SUBJECT: THREE MILE ISLAND NUCLEAR STATION, UNIT 2 (TMI-2)  
POSSESSION ONLY LICENSE NO. DPR-73  
DOCKET NO. 50-320  
UPDATE 7 OF THE POST-DEFUELING MONITORED STORAGE SAFETY  
ANALYSIS REPORT

**UNIT 2 PDMS Safety Analysis Report Instruction Memorandum  
UPDATE 7**

**TMI-2 POST-DEFUELING MONITORED STORAGE**

**UPDATE 7  
AUGUST 2007**

| PDMS SAR<br>FIGURE: 10.5-1   | UPDATE 7 - Aug. 2007<br>PAGE 10.5-4 |

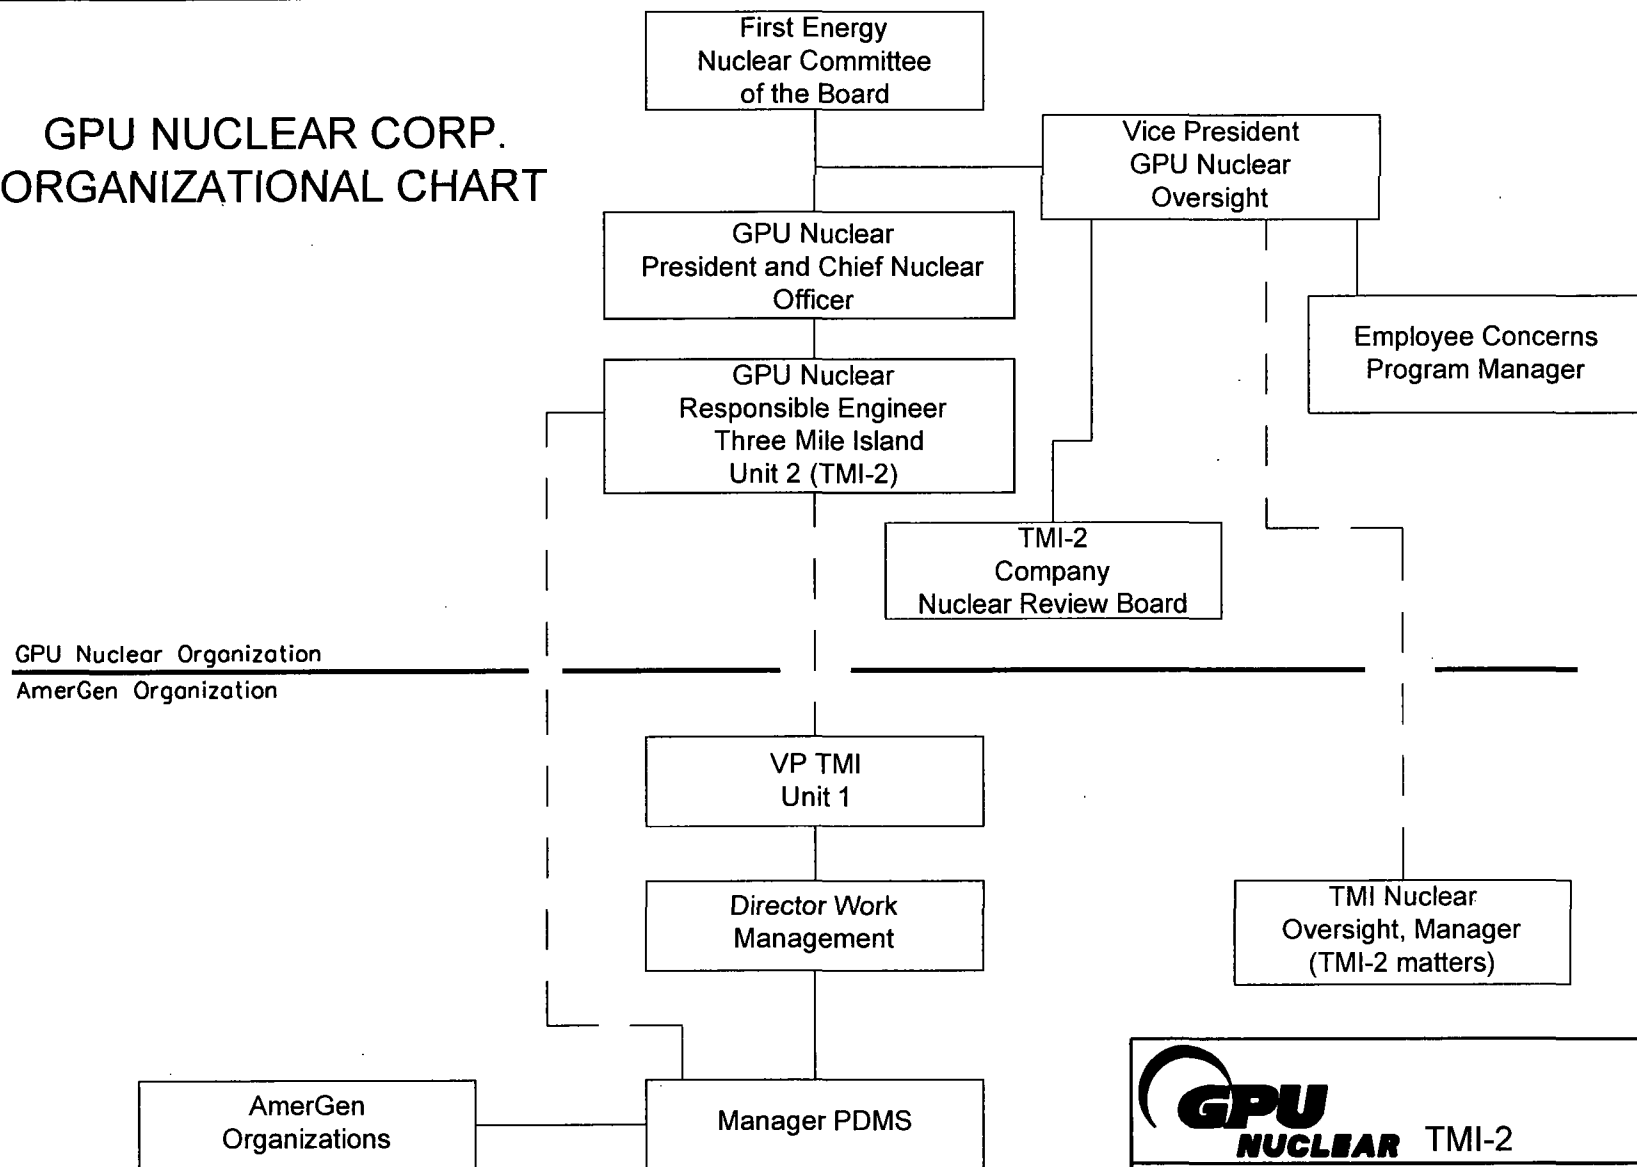
The organizational elements responsible for the PDMS phase of TMI-2 are shown on Figure 10.5-1. The specific responsibilities are discussed below. Additionally, the PDMS Technical Specifications prescribe specific requirements for staff qualifications, training, and the review and audit of TMI-2 activities.

Figure 10.5-1 also shows the AmerGen organization which will provide the above services.
